Access Compliance Report Public Rights-of-Way (Curb Ramps)

Main Street: FLINTRIDGE_AVE Cross Street: FLINTRIDGE_AVE Location: N

ADA ID: RPAT220208143007 Ramp Type: Type 4 - Parallel Initial Pass/Fail: Fail Overall Compliance: No Severity Score: 2

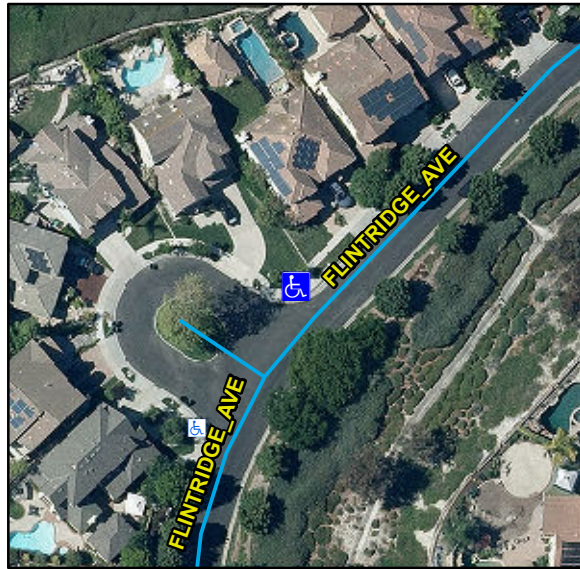
Compliance	Description	Data	Compliance	Description	Data
N/A	Ramp Length LT (in)	122	N/A	Ramp Length RT (in)	122
Yes	Ramp Width LT (in)	53	Yes	Ramp Width RT (in)	53
Yes	Ramp Run Slope LT (%)	8.3	Yes	Ramp Run Slope RT (%)	5.8
No	Ramp Cross Slope LT (%)	3.2	Yes	Ramp Cross Slope RT (%)	1.6
N/A	Landing Present	N/A	N/A	DWS Provided	N/A
N/A	Landing Length (in)	N/A	N/A	DWS Contrast	N/A
N/A	Landing Width (in)	N/A	N/A	DWS Length (in)	N/A
N/A	Landing Run Slope (%)	N/A	N/A	DWS Full Width	N/A
N/A	Landing Cross Slope (%)	N/A		DWS Offset Type	N/A
N/A	Landing Movement Obstructed?	N/A	N/A	DWS Offset Left (in)	N/A
	Landing Movement Type	N/A	N/A	DWS Offset Right (in)	N/A
N/A	Landing Shared	N/A			
N/A	Clear Space	Yes			
N/A	Clear Space To Crosswalk (in)	N/A			
N/A	Marked Crosswalk 1	No	N/A	Marked Crosswalk 2	No
	Crossing 1 Direction	W		Crossing 2 Direction	S
	Marked Crosswalk 1 Width (in)	N/A		Marked Crosswalk 2 Width (in)	N/A

Remove & Replace Curb Ramp With Two New Directional Ramps or Equivalent.

R204.3, R304.5.3, STD 1115
